CITY OF HOBART

City Planning Committee Meeting

Monday, 7 February 2022

7.1 APPLICATIONS UNDER THE HOBART INTERIM PLANNING SCHEME 2015	7
7.1.1 3 Greenlands Avenue, Sandy Bay - Alterations (Re-Roofing)	7
7.1.2 199 Macquarie Street, Hobart - Alterations to Carparking.....	58

Figure 1 Driveway Sight Lines

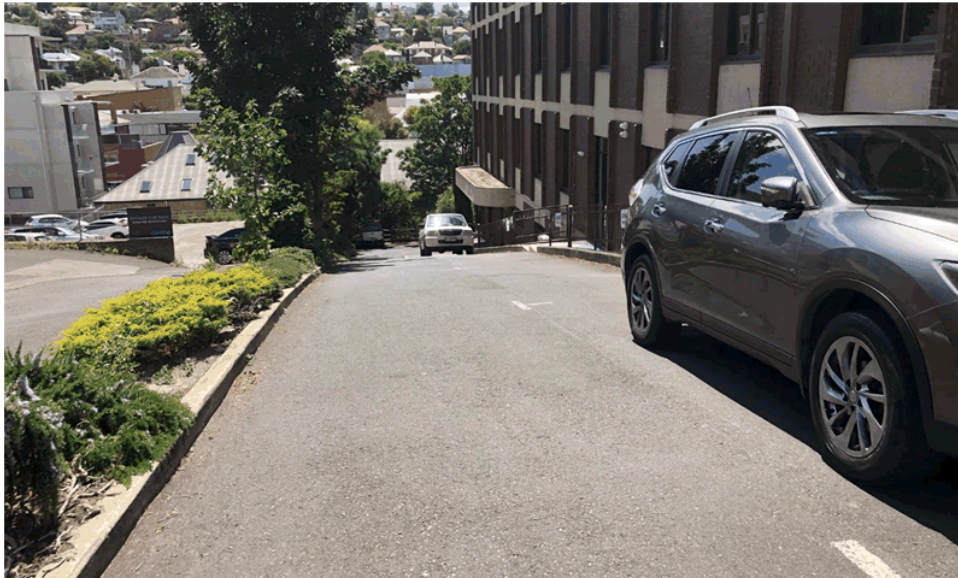
In this case the Acceptable Solution requires passing bays to be included. Two-way traffic is permitted in the driveway and no formal passing bay is provided. A single passing bay is available immediately behind the Macquarie Street kerb, however it measures 5.1 metres wide not 5.5 metres in accordance with A1:E6.7.3(b). No additional passing bay is provided along the length of the driveway, which measures approximately 40 metres in length. The driveway is shown in Figure 1.

On this basis, I am satisfied that the driveway is satisfactory in terms of safety and efficiency. The driveway meets the requirements of Performance Criteria P1 of Clause E6.7.3 of the Planning Scheme.

Figure 3 B85 Swept Path Entry Manoeuvres

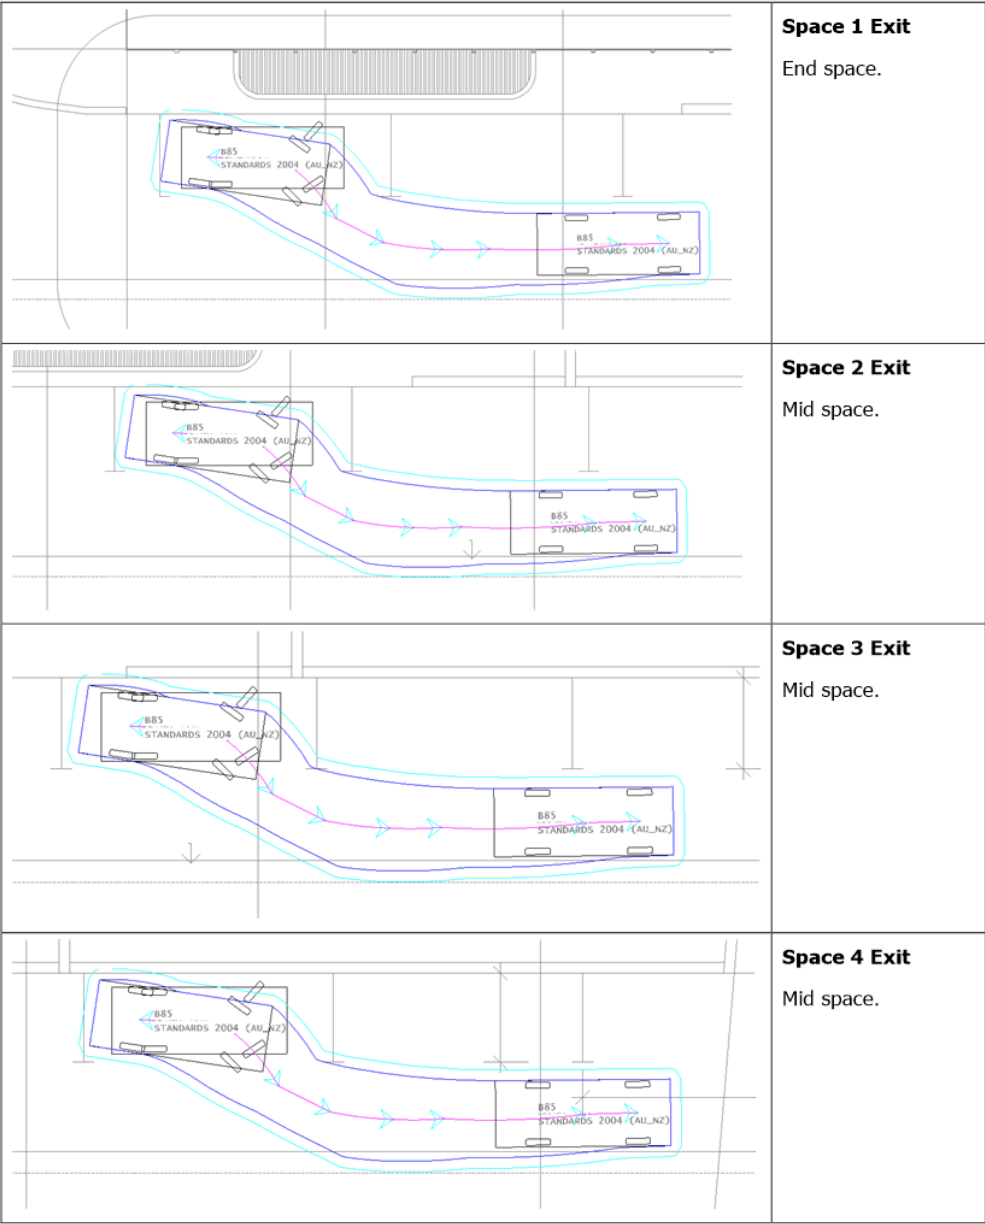
The swept paths are shown in Figure 3 and

It can be seen that all spaces can be accessed by a single turn entry and exit. Based on the findings of the swept path analysis in conjunction with the findings in Section 2 of this report and subject to the recommendation of lengthened spaces, it is my professional opinion that the car parking within the driveway ensures ease of access, egress and manoeuvring on-site. The Performance Criteria P1 of Clause E6.7.5 of the Planning Scheme is therefore met and the parking should be approved.

This report recommends lengthening the spaces to 7.0 metres resulting in the loss of 1 car parking space. This facilitates single turn entry and exit manoeuvres for a B85 vehicle for all spaces. The revised layout of the parking complies with the requirements of Performance Criteria P1 of Clause E6.7.5 of the Planning Scheme.

Fig.2 - The informally line marked spaces (hatched, in red) occupy an entire vehicle lane required to avoid user conflict (encircled, in yellow), and facilitate two-way traffic.

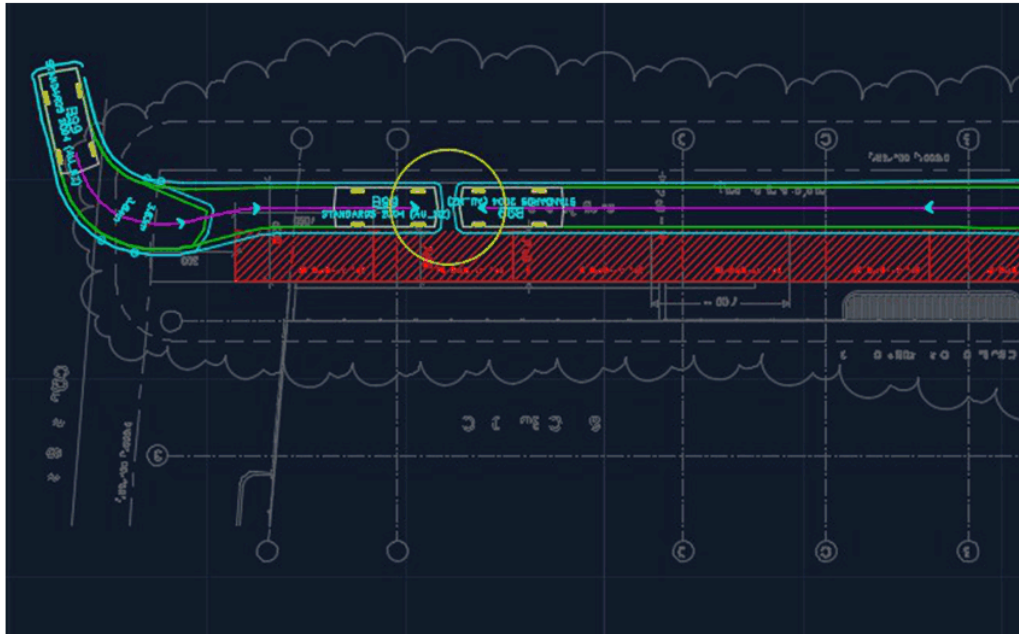
The lack of passing opportunities is not intrinsic to the circulation roadway, this is an introduced hazard due to the informally line-marked spaces (see Fig.2). Through assessment, vehicle passing areas along the access have been determined to be a necessity, especially when considering the 38 existing car parking spaces located behind the lot. The large number of existing spaces will invariably produce a high volume of daily traffic needing to enter and exit the lot. This was evidently the design consideration of the original circulation roadway's geometry (i.e. two-way carriageway width). The lack of a practical passing area at the lot frontage access, would force vehicles to reverse onto the public road and into incoming traffic, or halt on the highway and block the access of 201 Macquarie Street, all of which are highly undesirable outcomes for the City and prohibited under AS/NZS 2890.1:2004 Section 3.2.2.

Fig.3. - A reverse entry swept path assessment provided by Midson Traffic showing, significant departure from the trafficable surface (outlined & shaded, in red), and why more than 2.5m of aisle width is required for manoeuvring despite the proposed lengthening of spaces to 7m.

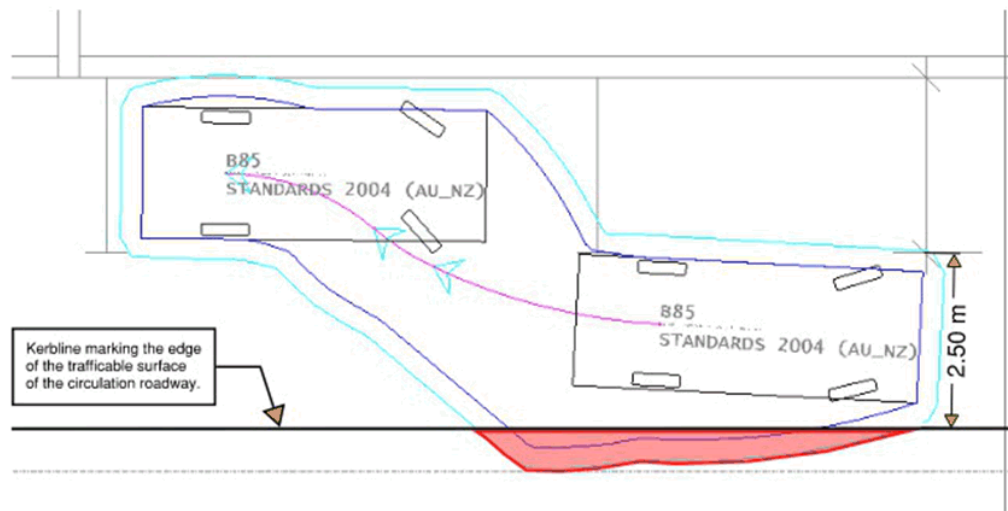
The 20% parking gradients, and the spaces' location limit the effective circulation roadway width to less than minimum. Perhaps more importantly, it is prudent to note such a layout would not in any case have been approved by the City, as it is essentially prohibited by design by national standards. During assessment, it was noted the submitted plans and documentation do not make particular reference or detail the unsuitable grades, bays' proximity to structural obstructions, and compromised manoeuvring clearances (see Fig.3). The proposed spaces also introduce a semi permanent obstruction within the circulation roadway, removing the principal circulatory function for the subject-site's car park, and introducing a sight line obstruction. Ultimately, compliance with other relevant design aspects (e.g. bay lengths) are inconsequential as all spaces are prohibited by default under AS/NZS 2890.1:2004, and the approval of these parking spaces would invariably conflict with the intended operation of the constructed carriageway.
